Project Title: EAST CENTURY GATEWAY PLAZA	Building Permit #:	City Drainage #: K20-D061
DRB#: EPC#:		Work Order#:
Legal Description: LOTS 1-3 EAST CENTURY GATEWAY PLAZA		
City Address: 10201 CENTRAL NE		
		Contact: DAVID SOULE
Engineering Firm: RIO GRANDE ENGINEERING		
Address: PO BOX 93924, ALBUQUERQUE, NM 87199 Phone#: 505.321.9099 Fax#: 505.8	72.0999	E-mail: DAVID@RIOGRANDEENGINEERING.COM
Phone#: 505.321.9099 Fax#: 505.8		
Owner: TEKIN PROPERTIES		Contact:
Address: 8036 OAK POINT DRIVE, FRISCO, TEXAS 75034		,,,,,,,,,,,,,,,,,,,,,,,,,,,,,,,,,,,,,,
Phone#: Fax#:		E-mail:
Architect: PETER BUTTERFIELD		Contact: PETER BUTTERFIELD
Address: Phone#: Fax#:		E-mail:
Phone#:		
Surveyor: SURV-TEK	<u> </u>	Contact: rUSTY hUGG
Address:		
Phone#: 9 Fax#:	,	E-mail:
Contractor:		Contact:
Address:		
Phone#:		E-mail:
	CHECK TVPE OF APPROV	VAL/ACCEPTANCE SOUGHT:
TYPE OF SUBMITTAL:	SIA/FINANCIAL GUARAN	
DRAINAGE REPORT	PRELIMINARY PLAT API

RE: East Century Gateway Plaza
Grading and Drainage Plan
Engineers Stamp Date 6/11/14 (K20-D061)

RE: Drainage Resubmittal

Re: Tracts 1 & 3 East Central Gateway Plaza, 10201 Central Avenue NE, Traffic Circulation Layout

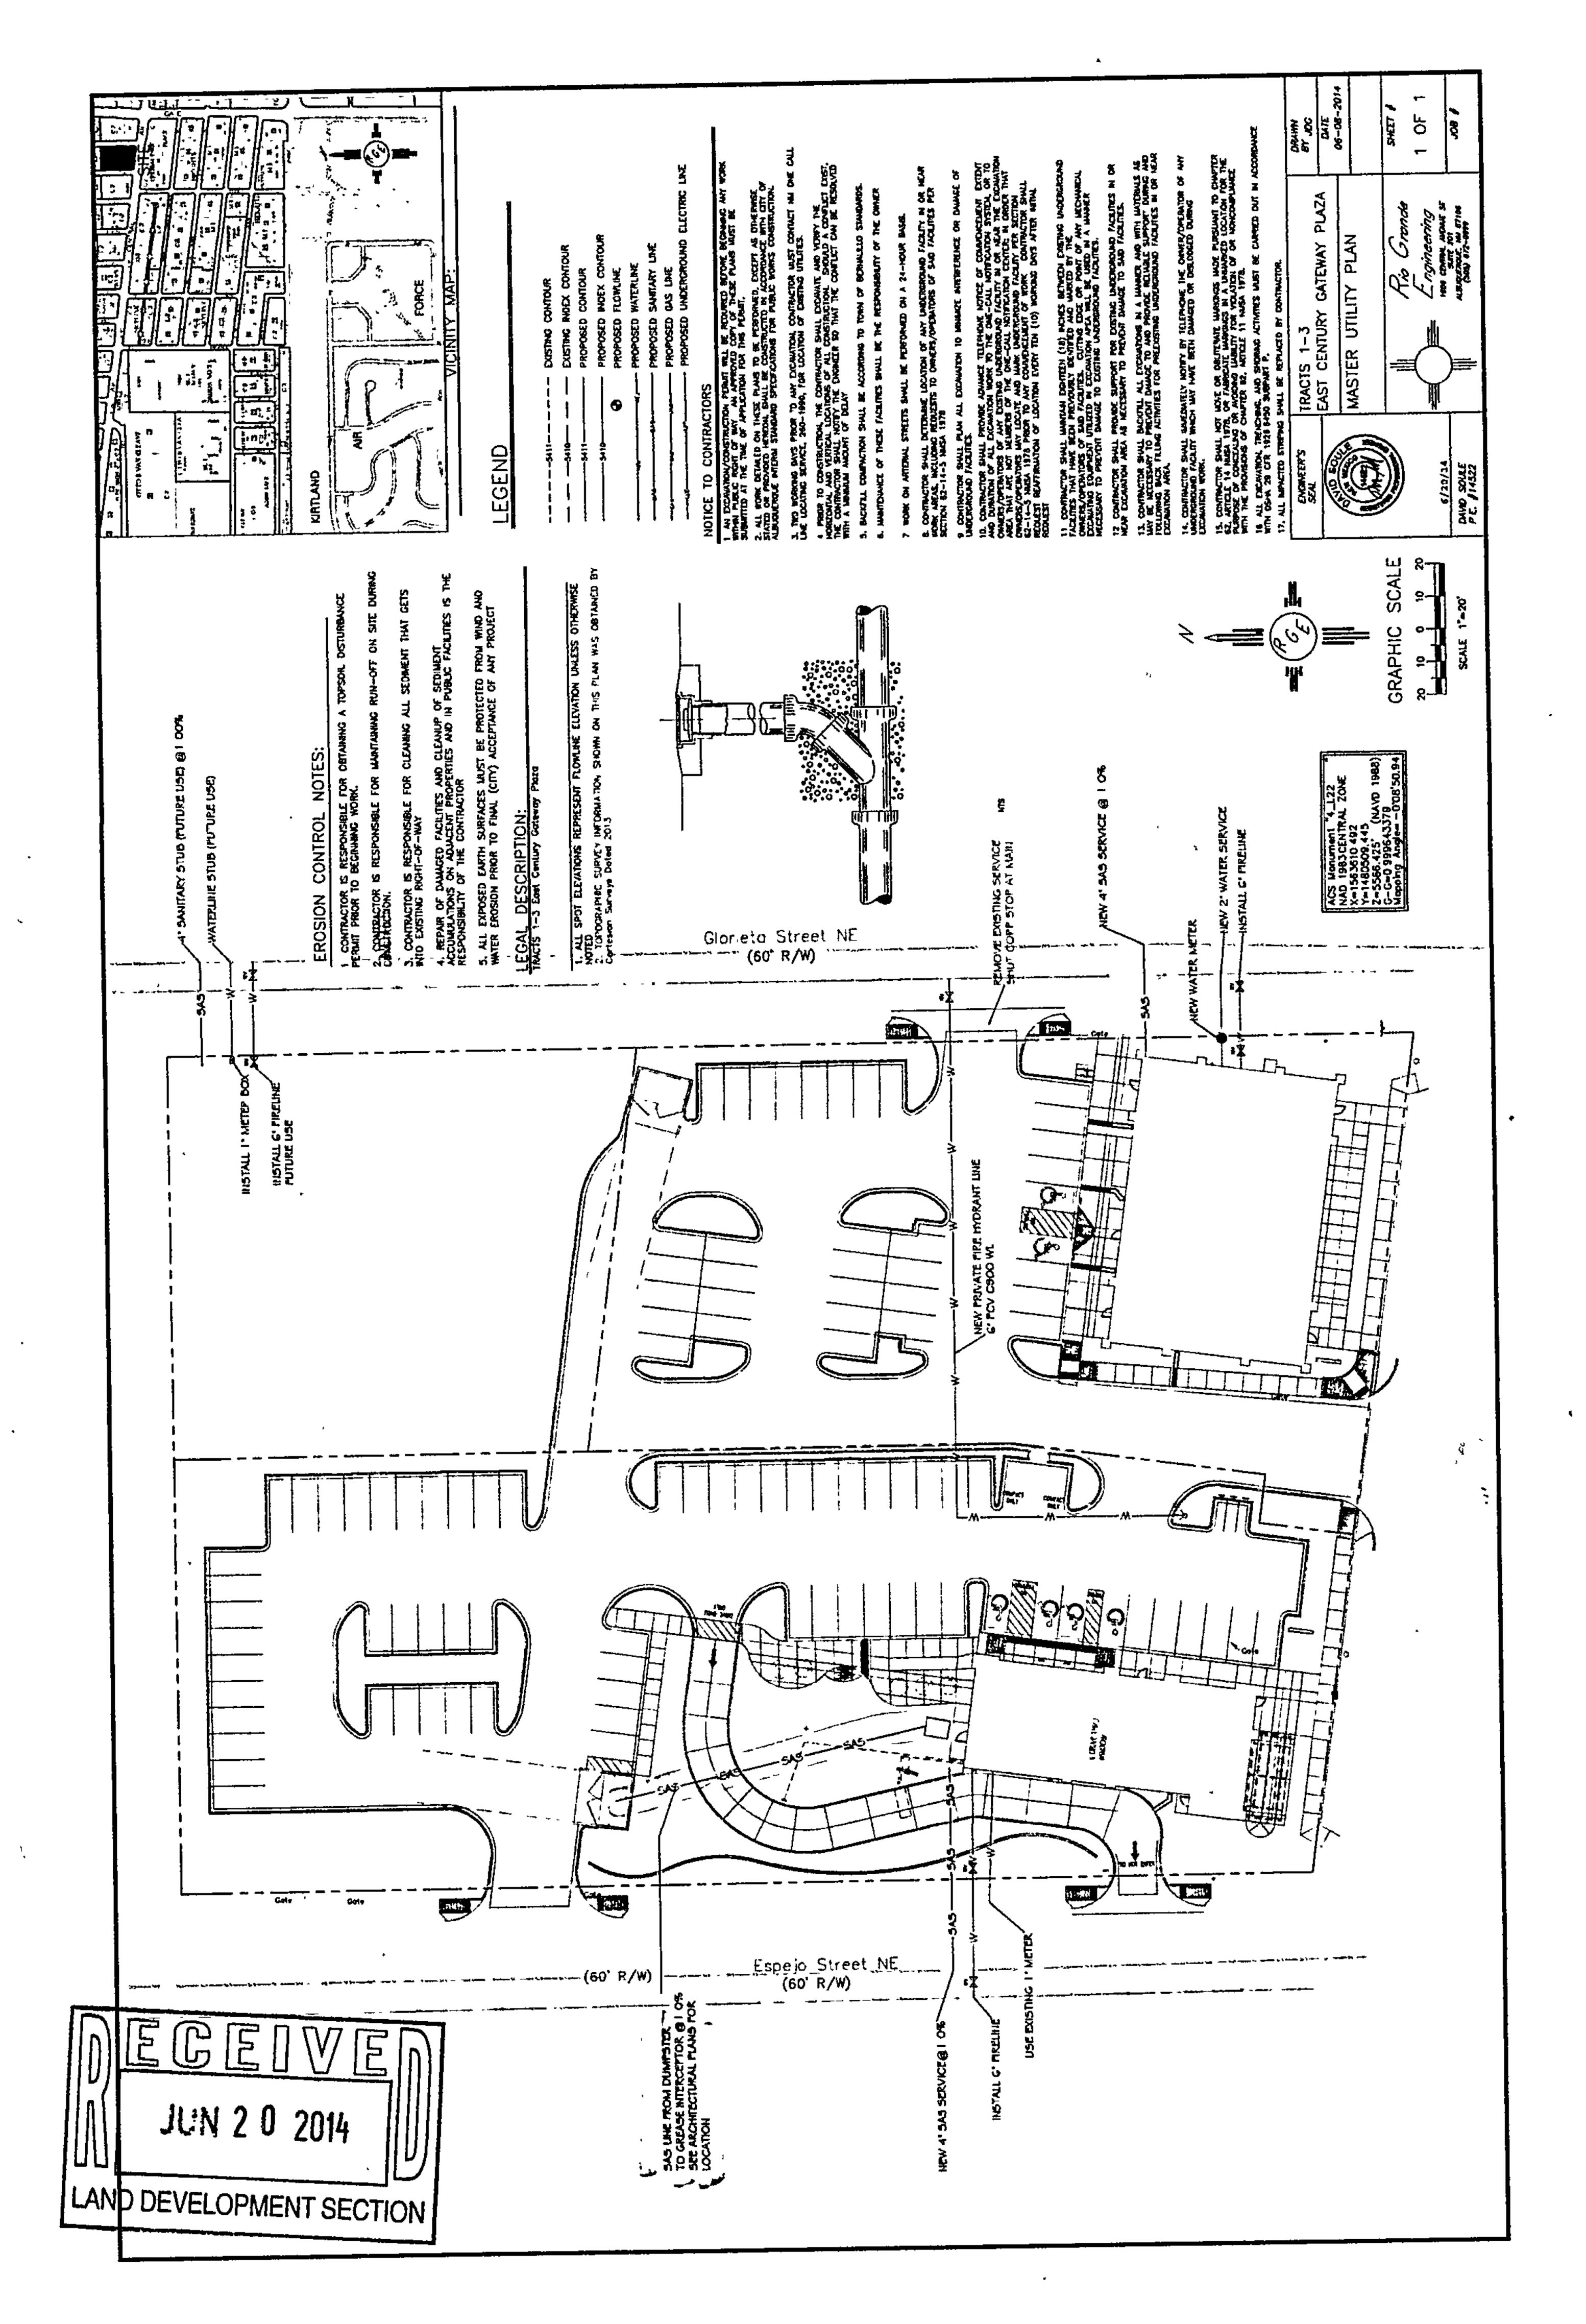
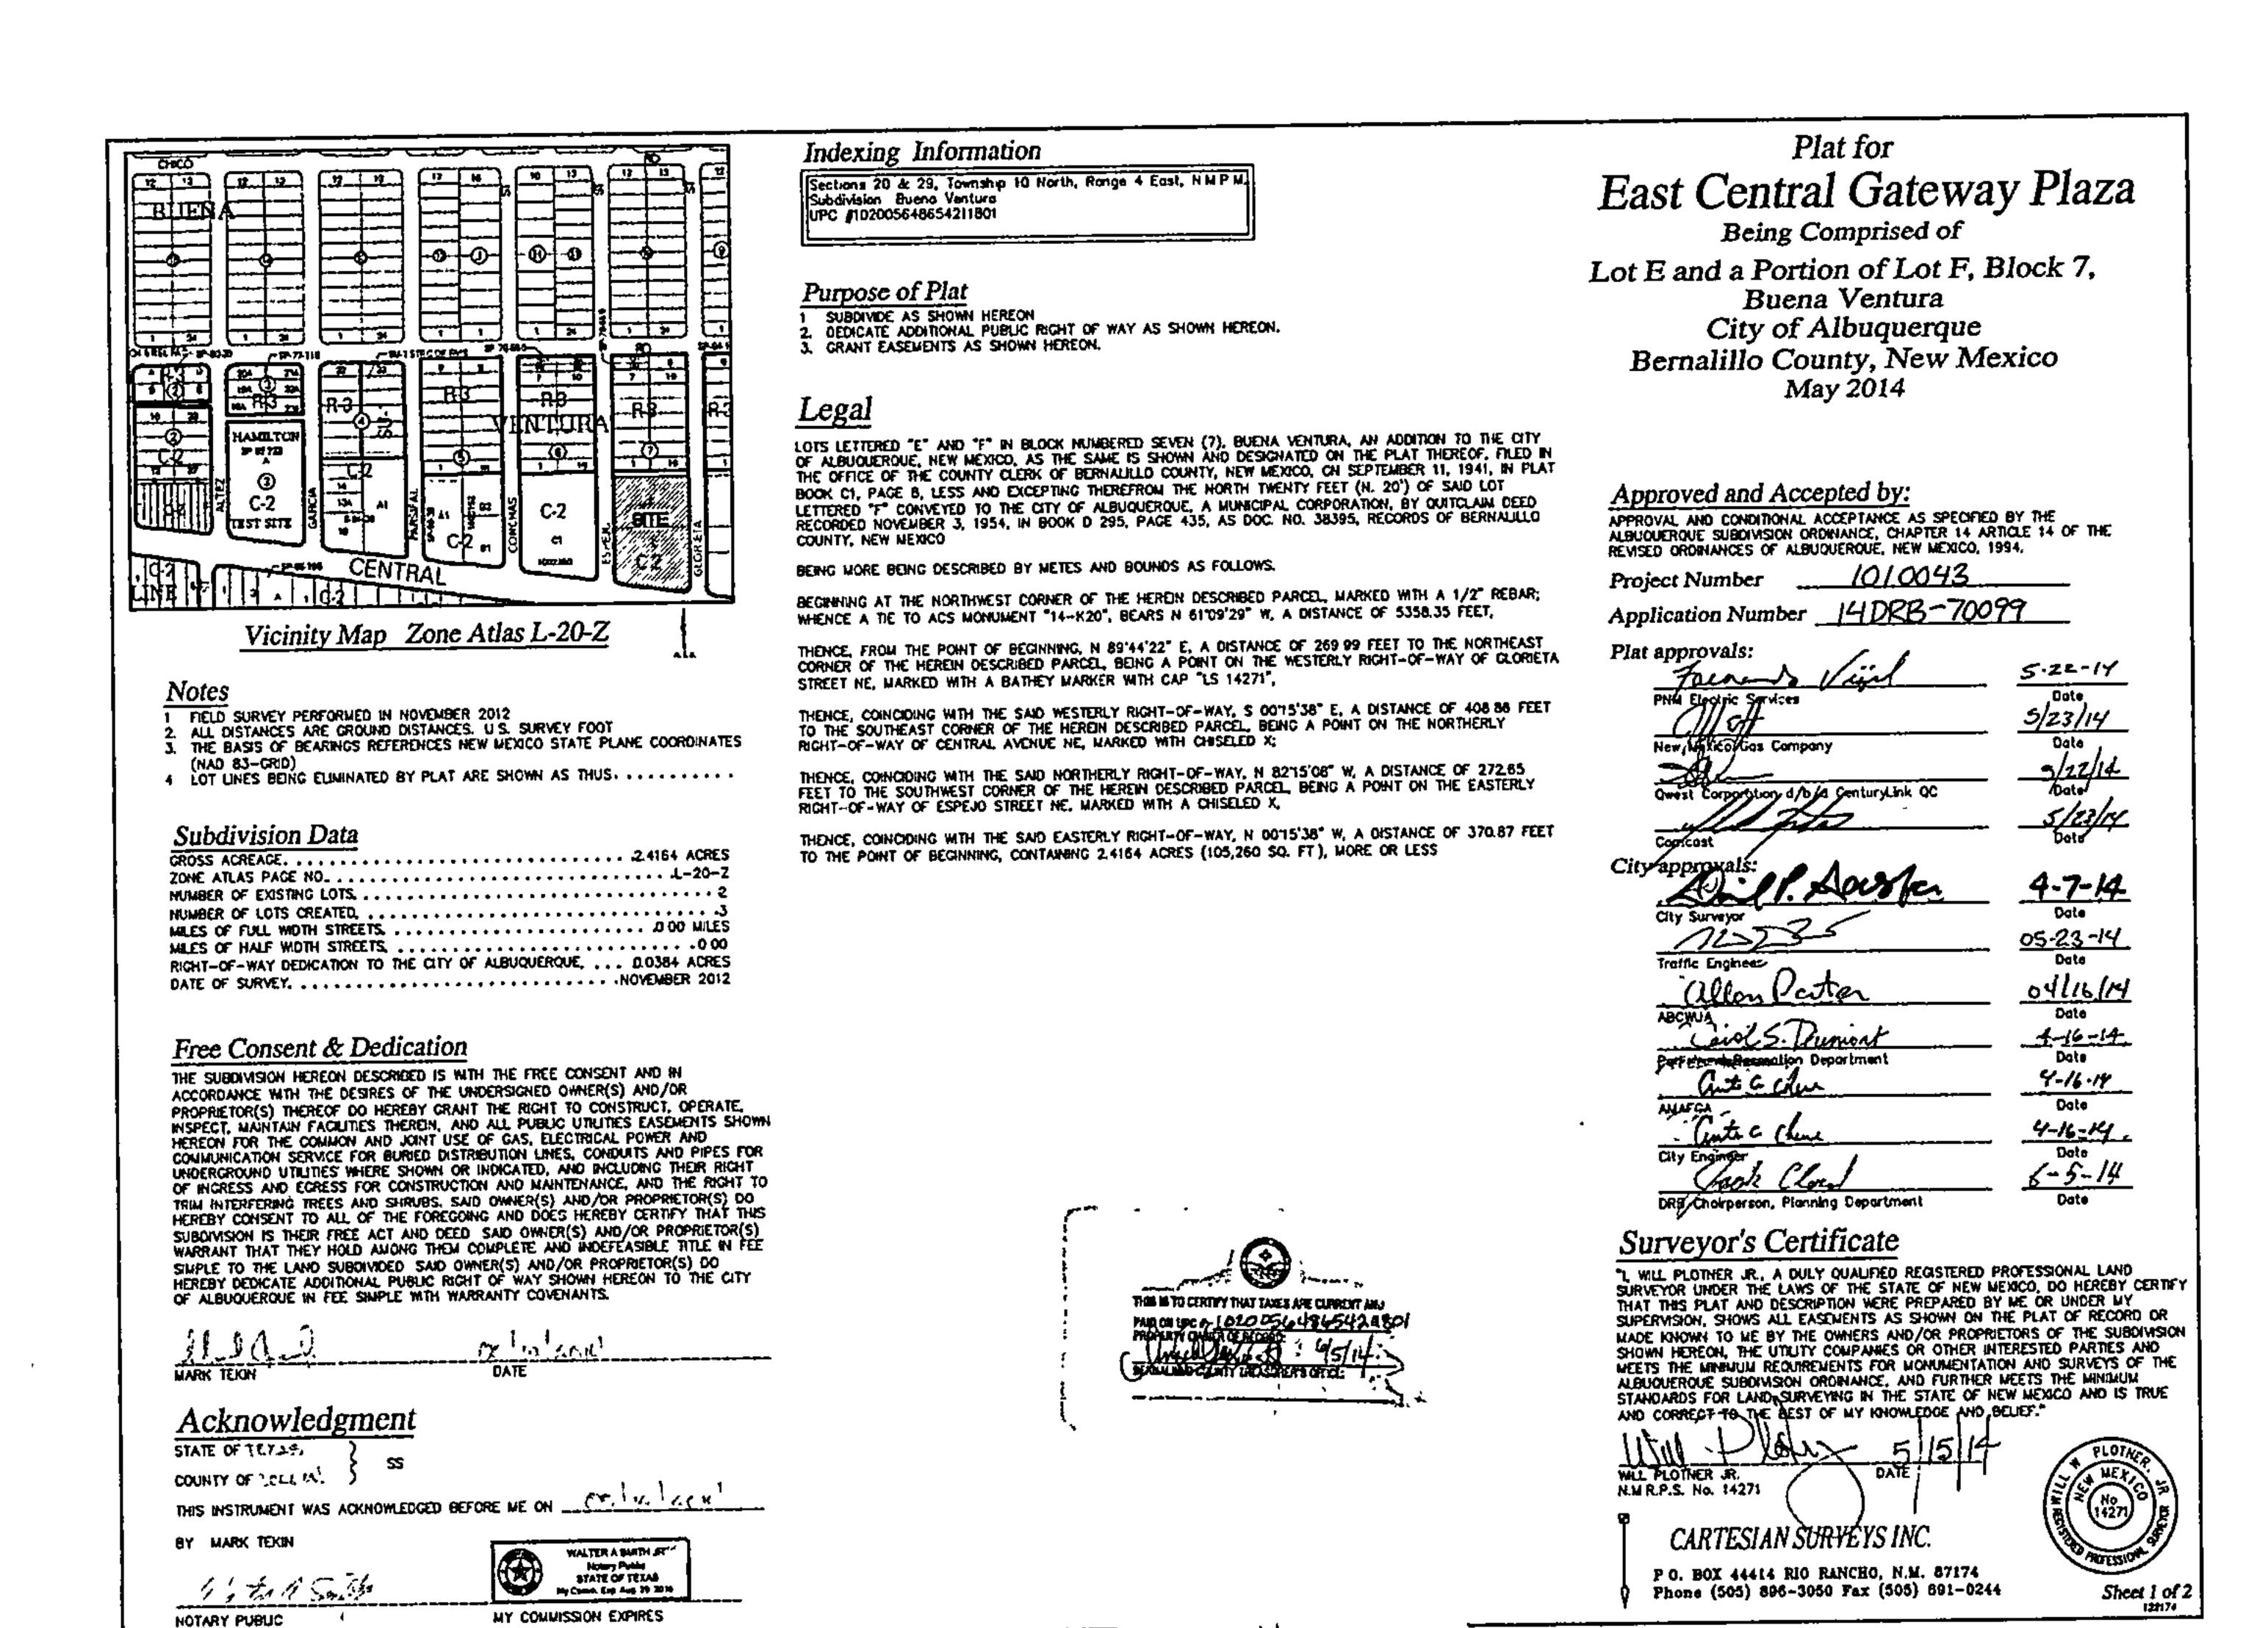
Based upon the information provided in your submittal received 6/11/2014, the above referenced Grading and Drainage Plan cannot be approved for Grading Permit or Building permit until the following comments are addressed.

- A drain with a grease trap needs to be placed in the trash enclosure.
- Add two foot curb cuts spaced every 20 feet in the drive thru lane.

The purpose of this letter is to accompany the revised plan. The plan has been revised to address your written comments dated June 19, 2014. The following is a summary of your comments and he corrections we have done to address.

- 1. A drain from grease trap must be placed in trash enclosure.

Added a note to the plan stating this requirement. I have included a reduced copy of the master utility plan to show we will be constructing this feature
- 2. Add two foot curb cuts at drive thru lane.

We have added two additional curb cuts to the drive thru lane. The lane was designed to have a 1% slope to a single opening, the additional cuts improve the design
